# Access Compliance Report

## Public Rights-of-Way

Intersection ID: 15217	Main Street: ALBEMARLE_RD	Cross Street: WINTERHAVEN_DR	Location: NW
ADA ID: 44B037ACDF31	Ramp Type: Perp	Initial Pass/Fail: Fail	Overall Compliance: No
Codes/Mitigation Info/Possible Solution		Field Measurements/Component Compliance

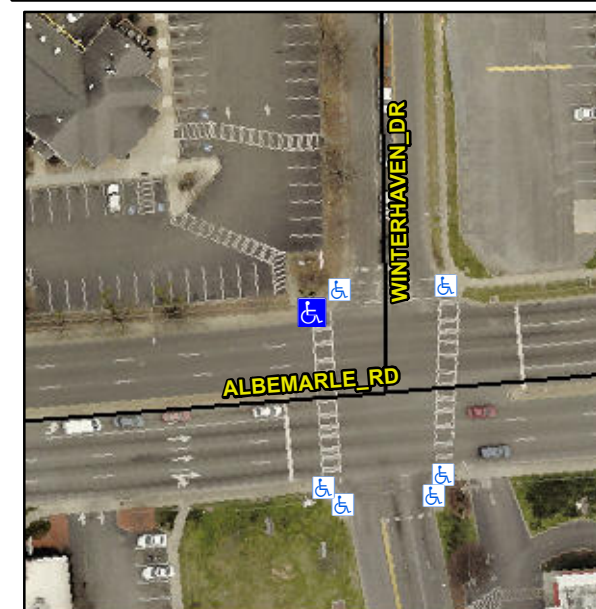
**Not Found, R304.5.1, R304.2.2**

Compliance	Description	Data	Compliance	Description	Data
N/A	Ramp Length (in)	59.0	No	Ramp Slope (%)	11.1
No	Ramp Width (in)	44.0	Yes	Ramp XSlope (%)	1.9
N/A	Flare Type LT	N/A	N/A	Flare Type RT	N/A
N/A	Flare Slope LT (%)	N/A	N/A	Flare Slope RT (%)	N/A
N/A	Flare Traversable LT?	N/A	N/A	Flare Traversable RT?	N/A
N/A	Landing Length (in)	N/A	N/A	DWS Provided?	N/A
N/A	Landing Width (in)	N/A	N/A	DWS Contrast?	N/A
N/A	Landing Slope (%)	N/A	N/A	DWS Length (in)	N/A
N/A	Landing X Slope (%)	N/A	N/A	DWS Full Width?	N/A
N/A	Landing Curb? (Y/N)	N/A	N/A	DWS Offset (in)	N/A
N/A	Shared Landing?	N/A			
N/A	Gutter Ponding?	N/A	N/A	Gutter Slope (%)	N/A
N/A	Gutter Lip Ht (in)	N/A	N/A	Gutter X Slope (%)	N/A
N/A	Painted X Walk1?	Yes	N/A	Painted X Walk2?	N/A
	X Walk 1 Direction	To S		X Walk 2 Direction	N/A
N/A	X Walk 1 Width (in)	105.0	N/A	X Walk 2 Width (in)	N/A
	X Walk 1 Slope (%)	1.1		X Walk 2 Slope (%)	N/A
	X Walk 1 X Slope (%)	0.0		X Walk 2 X Slope (%)	N/A

**Remove & Replace Entire Ramp.**
